# MEMORANDUM

**From:** Planning Control Manager                      **To:** Head of Environment and Planning  
**Our Ref:** EP/DC/P/2018/1063                      **Your Ref:** MRJ/P/2018/1063  
**Date:** 15<sup>th</sup> January 2019

**Location:** O. S Grid Ref: 350 545 Land West of Bryn Isa, Vicarage Lane, Gresford, Wrexham.  
**Development:** Proposed residential development for 44 no. residential dwellings (of which 25% - 11 no. will be affordable ), public open space, landscaping, means of highway and pedestrian access, local highway and pedestrian infrastructure improvements along Vicarage Lane, foul sewerage pumping station and new off-street parking provision for existing residents.

# Turning Areas

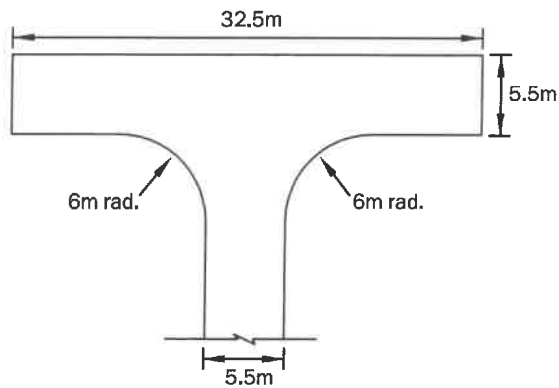
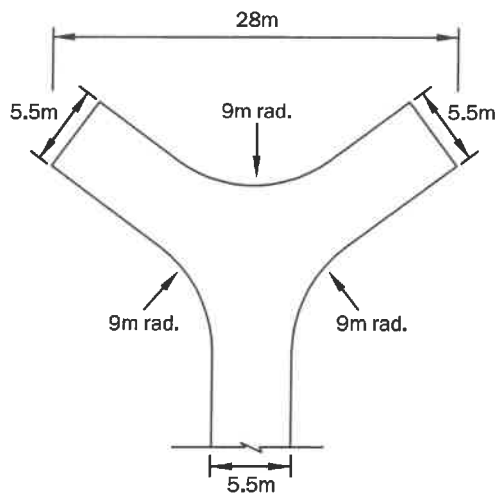
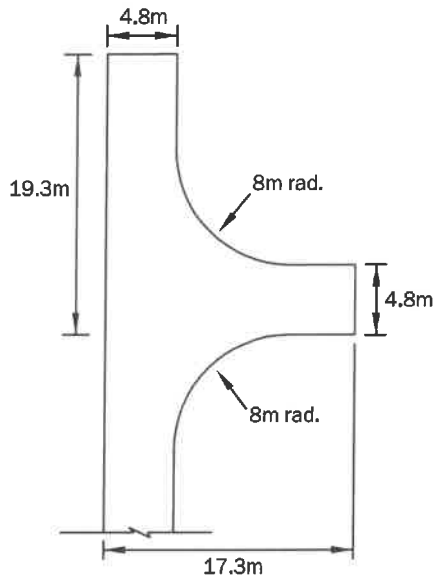
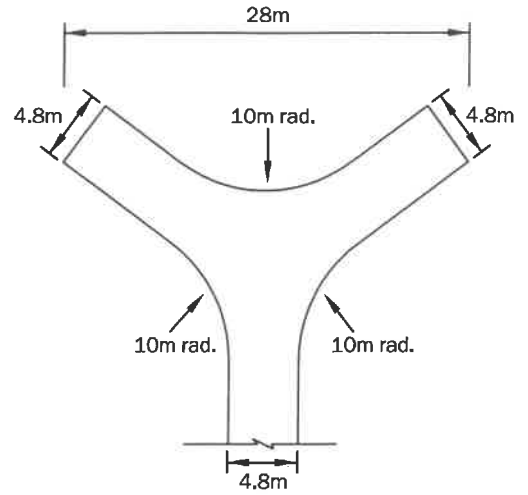
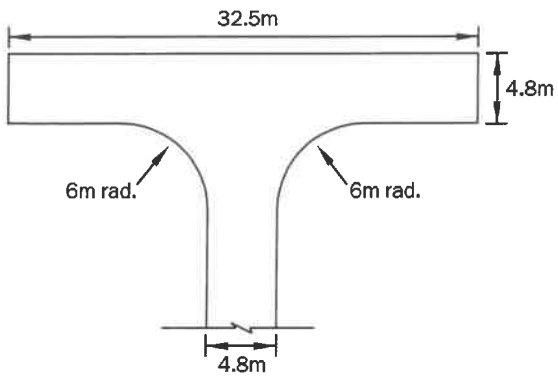
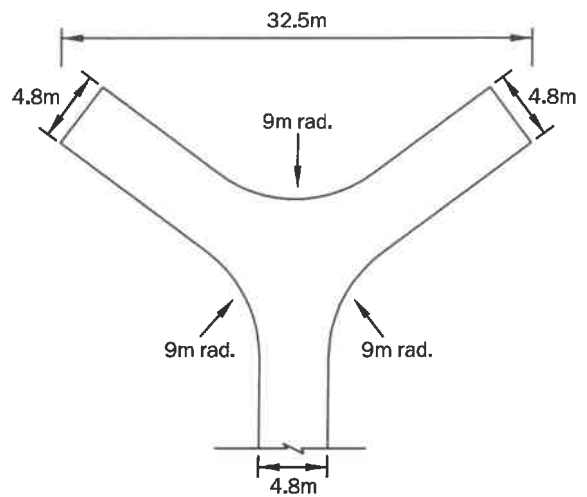
Indicates a 3.5T Panel Van turning within the access road serving plots 1 – 8. I would recommend that a suitable turning head is provided to accommodate the turning movements of a medium sized delivery vehicle (see attached detail). Please ask the applicant to provide an amended layout plan indicating this detail.

Indicates a 7.5T Box Van turning within the access road. I would recommend that a suitable turning head is provided to accommodate the turning movements of an 11.2m long refuse vehicle (see attached detail). Please ask the applicant to provide an amended layout plan indicating this detail.

Turning areas are based on an 11.18m long, 2.55m wide refuse vehicle.

# PARKING AND DRIVEWAY ARRANGEMENTS

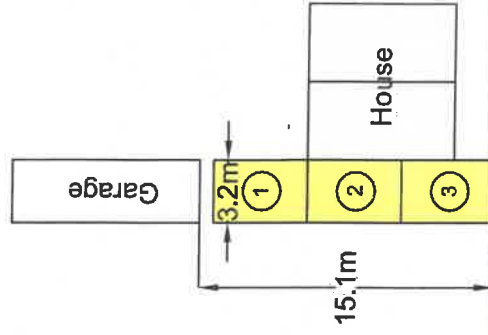
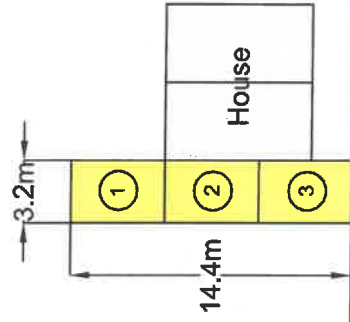
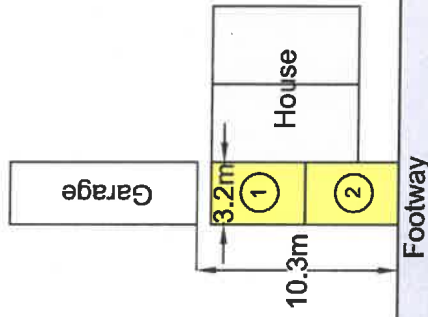
**Could you please ask the applicant to provide a revised layout plan annotating the proposed individual driveways in accordance with WCBC Standard Driveway dimensions (see attached detail).**
